P/V Stimson Shipyard Repairs

ITB 2022-1200-4961

Amendment Three

Questions submitted by potential offerors and answers from the state

Picture 1

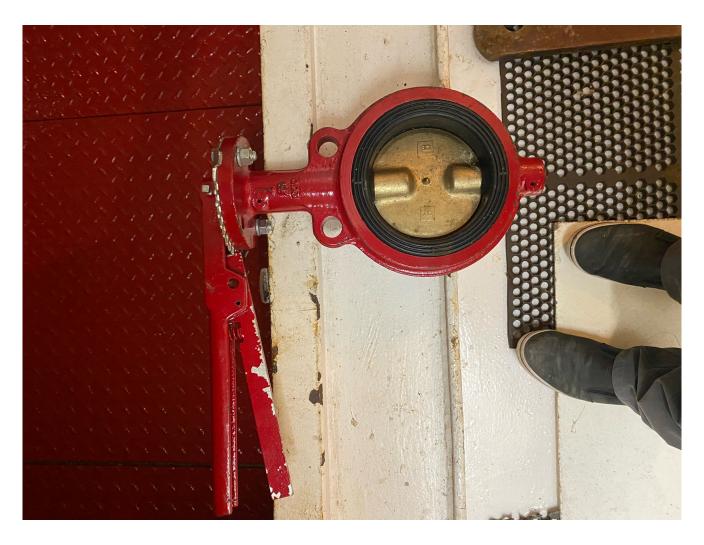
Question 2: In specification section 4.6.7 Replacement vales Valve # 12 &13 (Demco Butterfly) what is the body and trim material, and are these gear or lever operated? Balance of the valves, what is the trim (seat, disc and stem) material?

<u>Answer:</u> The Demco Butterfly valve is an 8", grey iron body, with a brass disc. It is lever operated. Picture 1 attached.
